MEMORANDUM

TO: Historic Preservation Board
 FROM: Merrillyn C. Rathbun, Fort Lauderdale Historical Society
 SUBJECT: Agenda for December 5, 2016
 DATE: November 29, 2016

Case	H16015	FMSF#	
Review and Comment	Henry F. Kinney Tunnel/Tunnel Pedestrian Plaza		
Owner	FDOT/City of Fort Lauderdale		
Developer	City of Fort Lauderdale/Elizabeth Van Zandt		
Address	SE 6 th Avenue/Las Olas Blvd. Tunnel		
General Location	Intersection of East Las Olas Boulevard and South Federal Highway		
Legal Description	<p>A PORTION OF RIGHT OF WAY AT THE INTERSECTION OF EAST LAS OLAS BOULEVARD AND SOUTH FEDERAL HIGHWAY IN SECTION 11, TOWNSHIP 50 SOUTH, RANGE 42 EAST MORE PARTICULARLY DESCRIBED AS FOLLOWS:</p> <p>BEGIN AT THE NORTHEAST CORNER OF TRACT 2, "BURNHAM'S SUBDIVISION", ACCORDING TO THE PLAT THEREOF, RECORDED IN PLAT BOOK 15, PAGE 29, OF THE PUBLIC RECORDS OF BROWARD COUNTY, FLORIDA; THENCE SOUTH 87°34'20" WEST ALONG THE NORTH LINE OF SAID TRACT 2 AND ALSO BEING THE SOUTH RIGHT OF WAY LINE OF EAST LAS OLAS BOULEVARD, A DISTANCE OF 23.00 FEET; THENCE NORTH 02°33'11" WEST, A DISTANCE OF 80.00 FEET; THENCE NORTH 88°05'12" EAST, A DISTANCE OF 36.70 FEET; THENCE NORTH 01°54'48" WEST, A DISTANCE OF 75.

Fig. 1 Tunnel slip road, U.S. 1, looking north

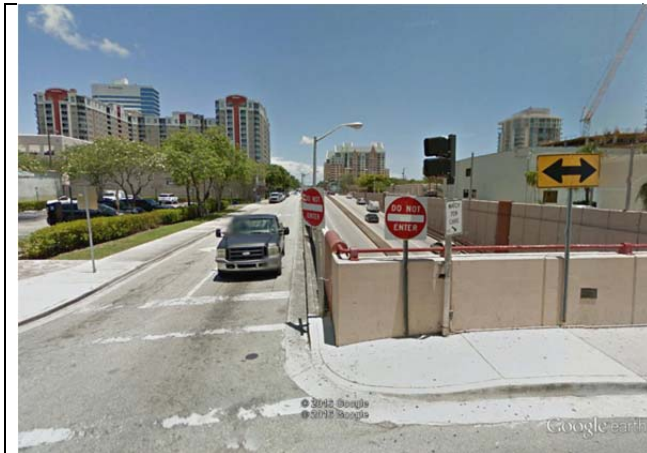
~~**Description of the Project:** The applicant has brought a project to the Board to build a pedestrian plaza on top of the NR¹ eligible Henry F. Kinney tunnel. The project would involve structural changes to the tunnel. Presently, according to the applicant's report, an auto driver's sight, approaching the intersection at Las Olas Boulevard, is blocked by the height of the tunnel wall from seeing an approaching pedestrian trying to cross at the slip road.~~

Figure 1. Showing National Register listed properties, no. 1 Bryan Building and no. 2 New River Inn; Proposed development and H-1 Historic District (small buildings left side of picture) showing contributing properties and The Shippey House and the Replica Schoolhouse.

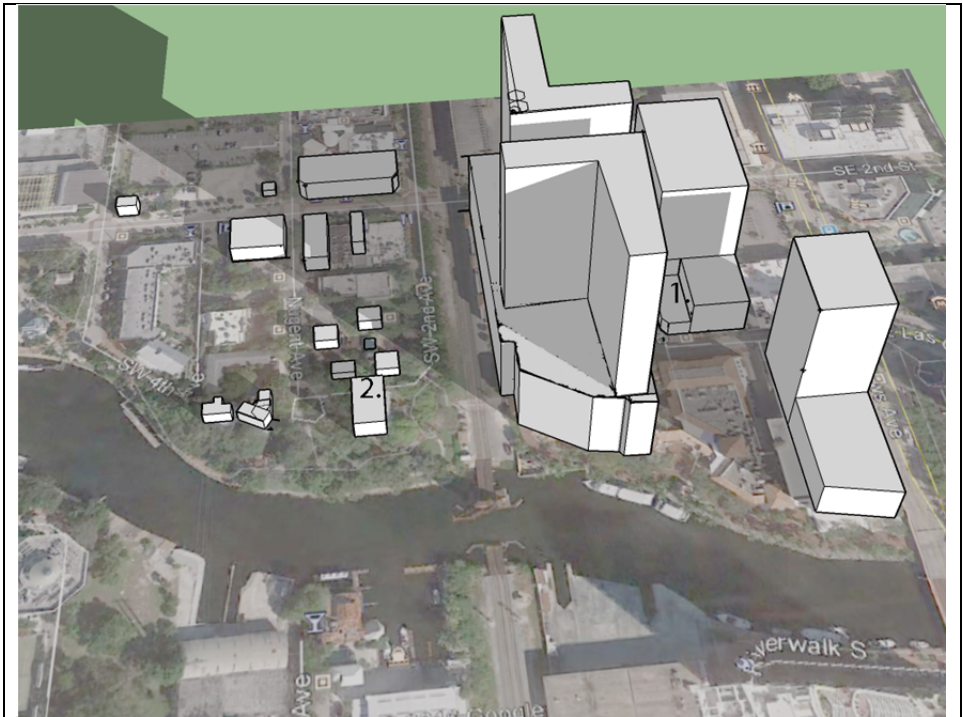
The proposed project is across Brickell Avenue from the NR listed Bryan Building (Fig. 1, no. 1) and is adjacent to the locally designated H-1 Historic District.

New construction in the H-1 District is limited to 25 feet in height; the tallest building in the district is probably the NR listed New River Inn at approximately 36 feet. The massive 41 story Riverfront project will create an immense wall effect effectively isolating the historic district from the downtown. A person standing on the front porch of the contributing Philemon Bryan Home would not be able to see the top of this project.
